IDAP REPORT

Property:	3 Wilson Street STRATHFIELD Lot C in DP 347221 DA 2021/198
Proposal:	Demolition of existing structures on site and construction of a two (2) storey dwelling house with basement storage, in-ground swimming pool and associated landscaping works.
Applicant:	H.A Design Group
Owner:	A Sopina and J Sopina
Date of lodgement:	16 August 2021
Notification period:	23th August 2021 – 11th September 2021
Submissions received:	Nil
Assessment officer:	L Fanayan
Estimated cost of works:	\$1,138,772.00
Zoning:	R2-Low Density Residential - SLEP 2012
Heritage:	No
Flood affected:	No
Is a Clause 4.6 Variation Proposed:	No
RECOMMENDATION OF OFFICER:	DEFERRED COMMENCEMENT APPROVAL

Figure 19: Proposed void spaces

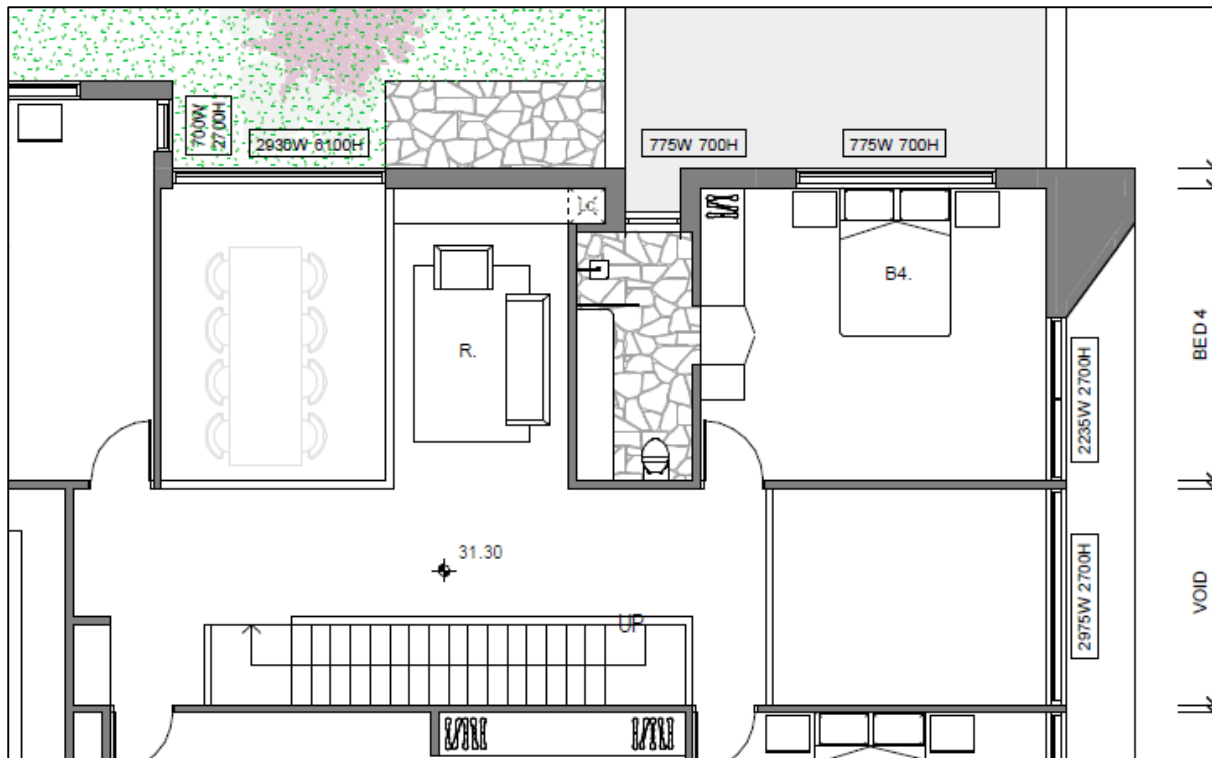
Bulk and scale was questioned in relation to the proposed voids, one 12.4m² and the other 11.13m². Total GFA proposed, as calculated by the assessing officer, was under the maximum allowance at 415.9m², giving a FSR of 0.564:1. After further information was requested it was proposed by the applicant to treat the void over the foyer as GFA for the purpose of FSR. The remaining GFA available according to the assessing officer's calculations was 8.03m², thus leaving 3.1m² as the void component and the proposal utilising the entire 423.93m² allowance of GFA. On this basis the proposed void over the foyer is considered acceptable.

The 12.4m² void on the northern aspect is accepted as it faces north and is functional, allowing for an increase in sunlight into the dwelling.

To ensure that the void spaces above the dining room and foyer remains a void an ongoing condition will be included in the consent.

Figure 20: Pool height above ground.

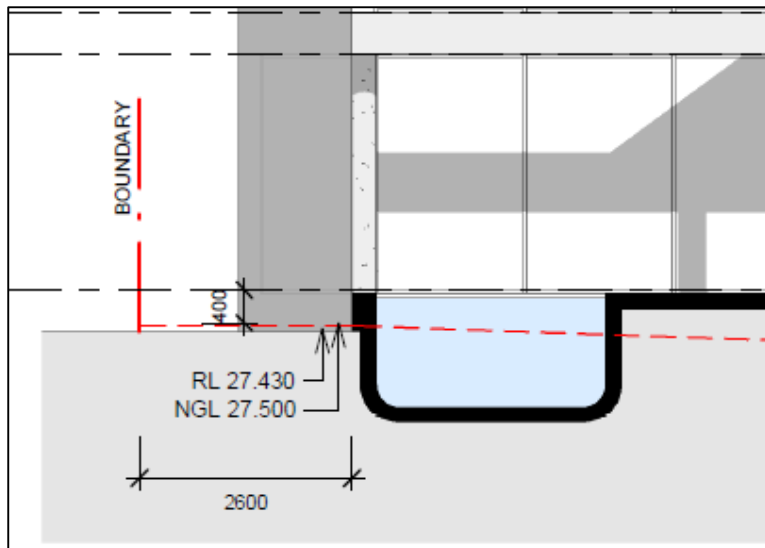
The pool is 0.4m above NGL and 0.47m above RL. The inclusion of boundary planting in combination with the 2.6m setback from the northern boundary will assist in minimising privacy impacts associated with the pool area. It is observed that the pool area will be adjacent to the driveway and vehicle manoeuvring area of No. 1A Wilson Street with the private open space of this neighbour being situated further away and to the north and west. As such, any overlooking impacts from this space are considered reasonable and acceptable.

Figure 21: Distance of driveway from street tree

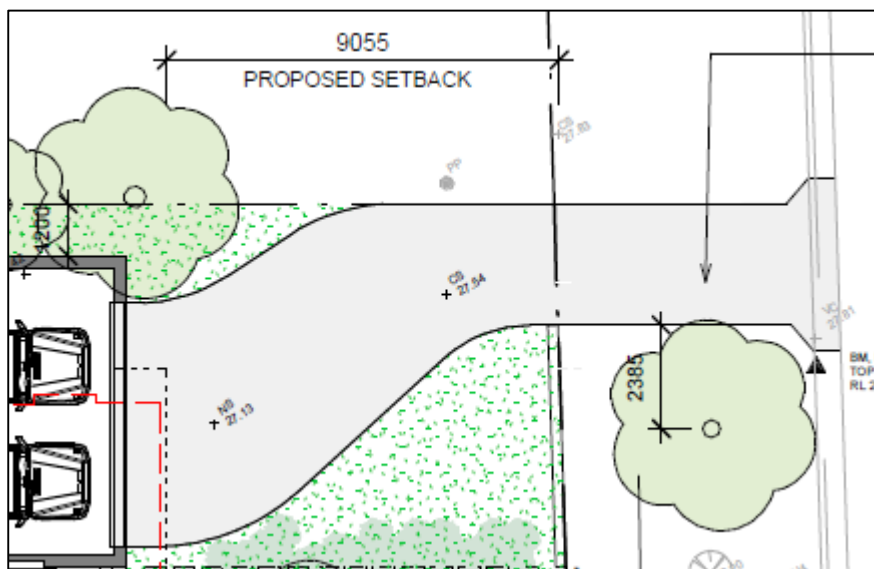
As outlined above there are variations required to the driveway that are supported to retain street trees. Further, the minimum width of the driveway is varied from 3m to 2.8m to maximise the TPZ for the street tree adjacent to the existing driveway. This provides a 2.385m separation from tree trunk to driveway edge.
